RE: JMC Project 20029  
Edward Jones Office  
150 Bedford Road  
Town of North Castle, NY

**Response to Town Comments Submission**

**Town of North Castle Planning Department, July 4, 2020**

**Kellard Sessions Consulting, P.C. Memorandum, dated July 9, 2020**

( IN FEET )  
1 inch = 10 ft.

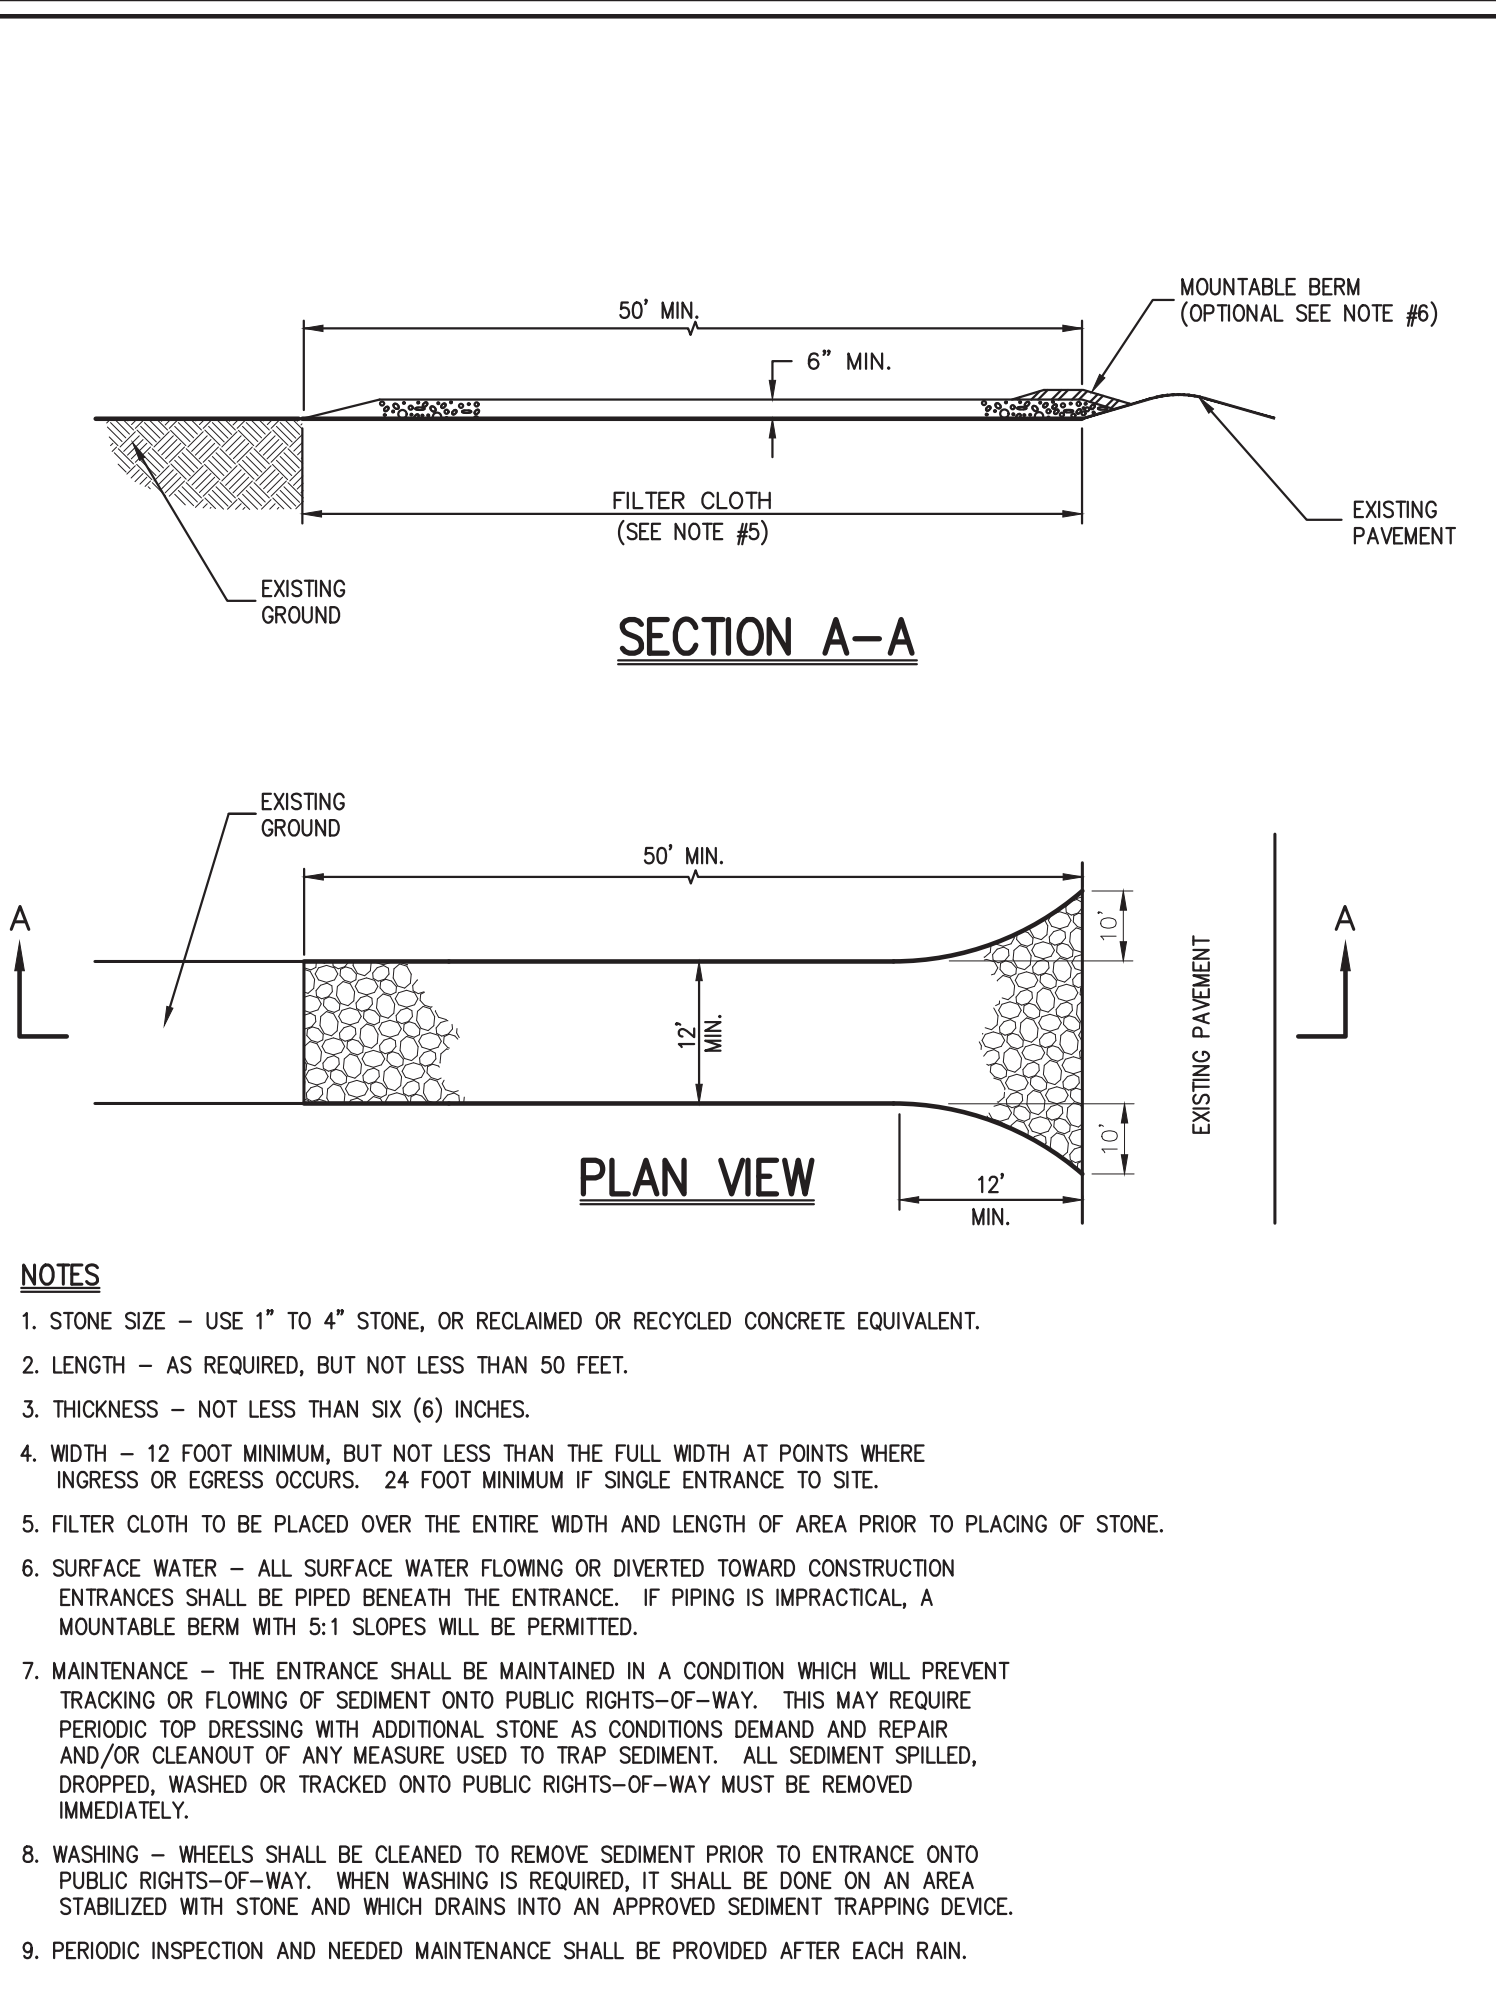
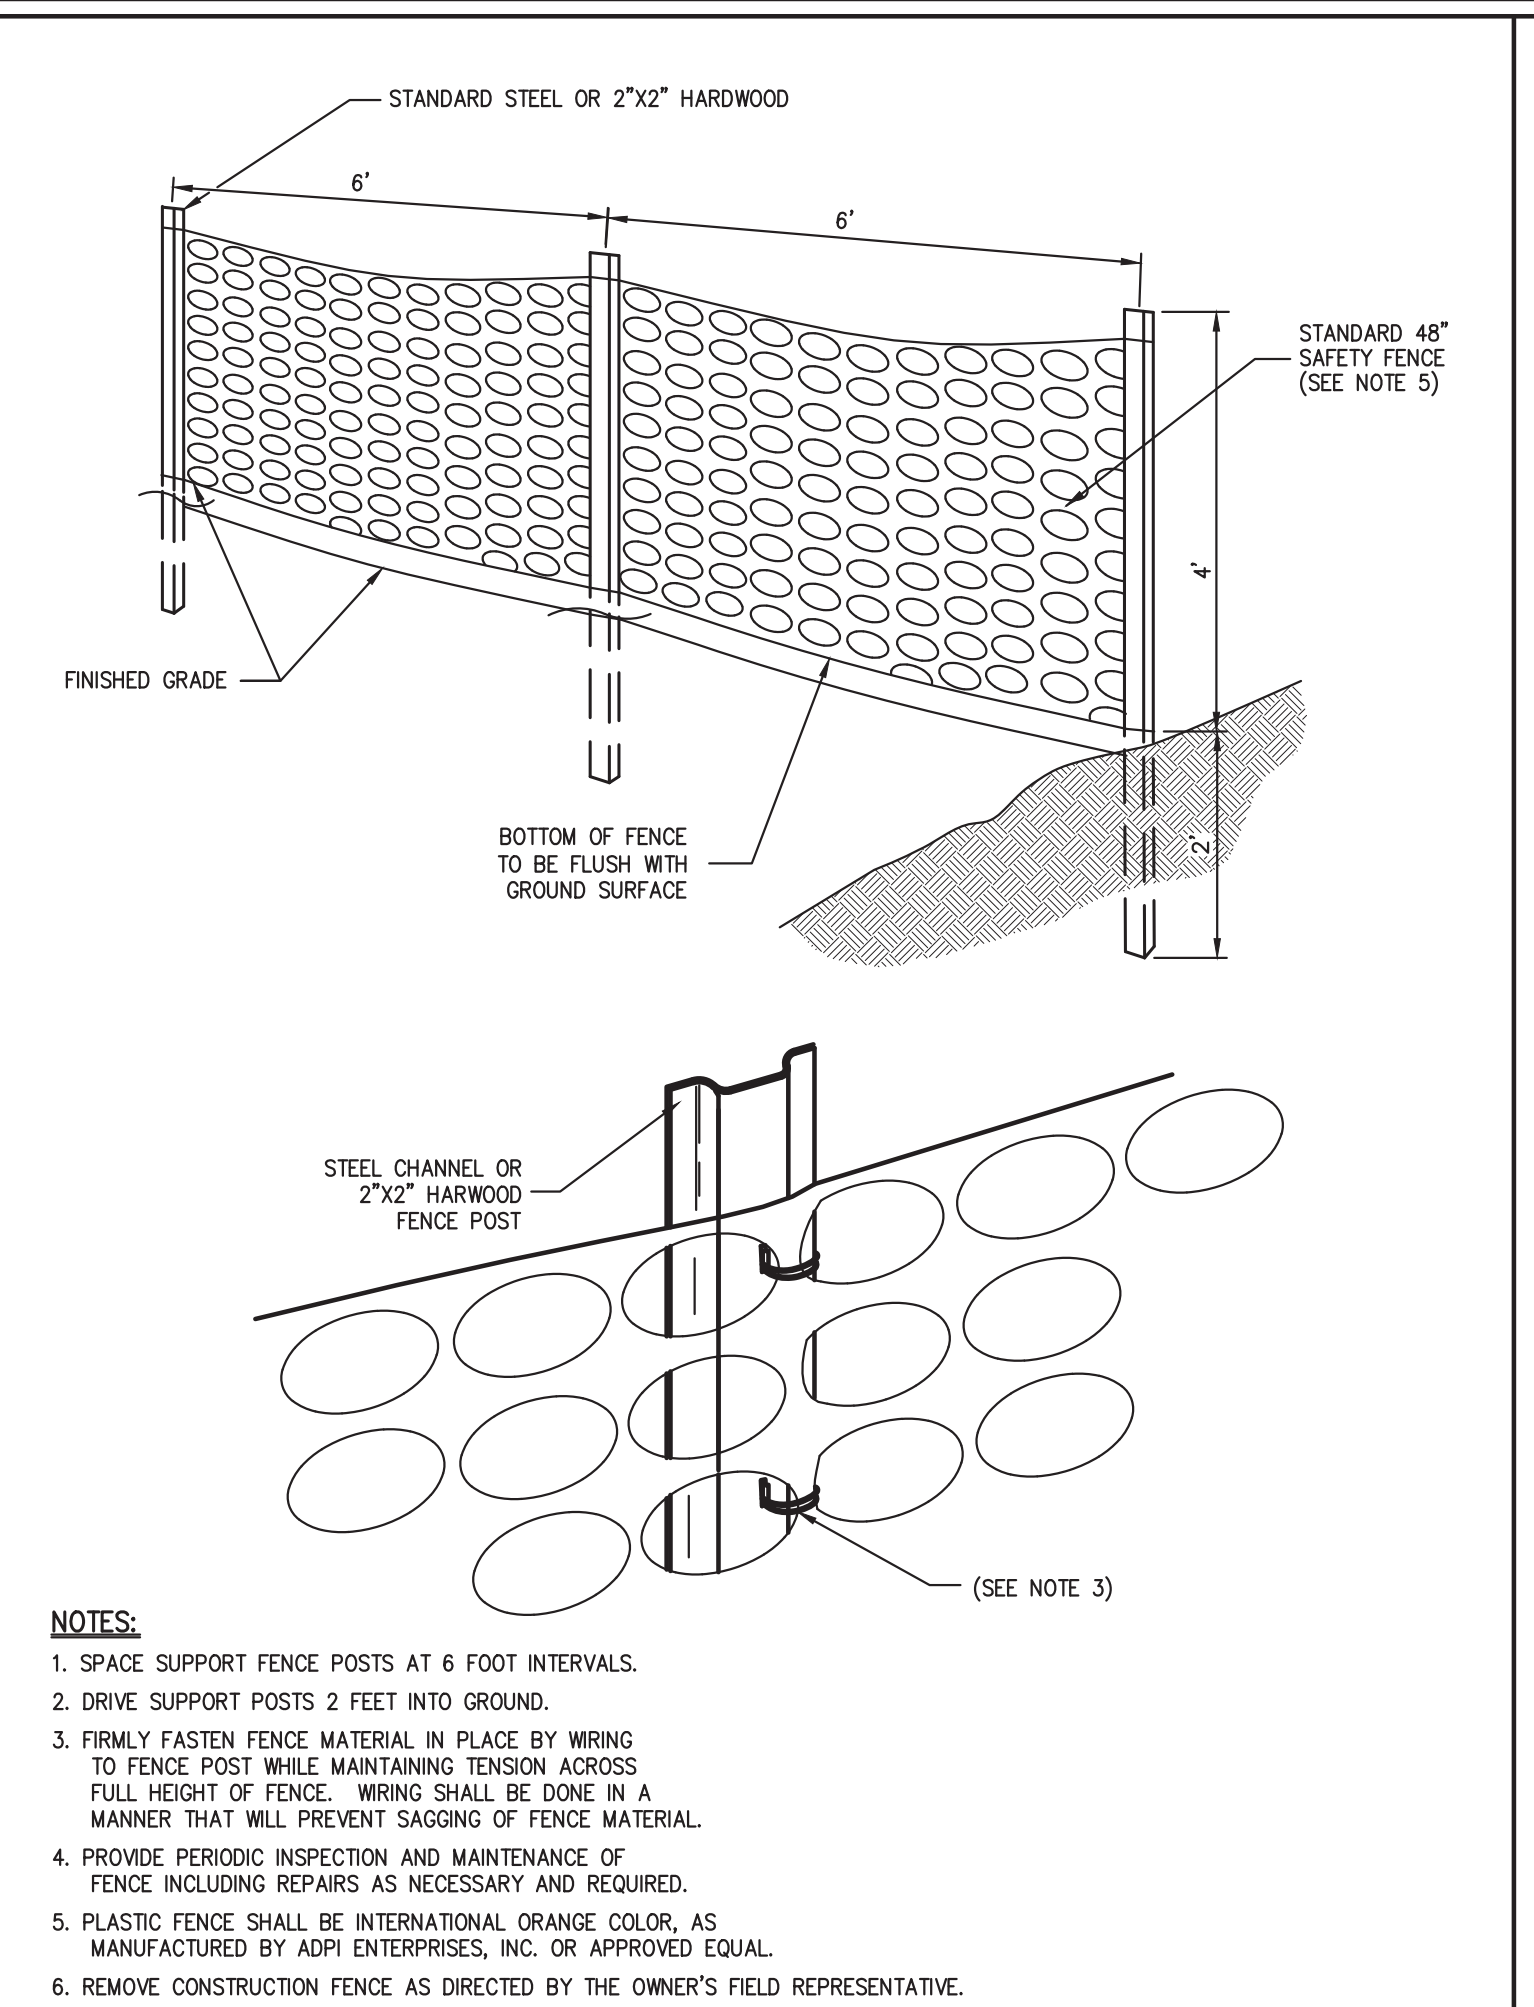
*The site plan shall be revised to depict the access drive dimensions in the vicinity of the new covered stairs on the eastern side of the building. Pursuant to Section 355-56.G. of the Town Code. The drive is required to be a minimum of 20 feet wide.*

*As previously noted, Section 355-56, G of the Town Code requires that access drives for parking areas serving between six (6) and twenty (20) spaces have a minimum width of 20 feet. The existing drive varies in width from approximately 12 to 15 feet. It appears an area variance will be required.*

*As previously requested, the plan has been revised to permit suitable access from the handicap access drive aisle to the ramp. However, the location of the “No Parking” sign shall be adjusted outside of the travel path.*

The access drive width has been dimensioned in the area of the proposed covered stairs. The width of the existing driveway has been determined to be existing non-conforming and will not be reduced in width under the proposed plan. Furthermore, based on the easterly curb location refinements and replacement the access drive has been increased to the maximum extent while also maintaining a planting bed along the easterly property line. The plan has been reviewed and approved by the Armonk Fire Department. Please refer to email correspondence from Armonk Fire Chief (Chief Phil Goulet), dated 07/07/2020.

The site plans have been revised to depict dimensions of the access drive, the width of which has not been reduced. Furthermore, based on the easterly curb location refinements and replacement the access drive has been increased to the maximum extent while also maintaining a planting bed along the easterly property line.

The site plans have been revised to relocate the proposed “No Parking” sign outside of the sidewalk travel path.
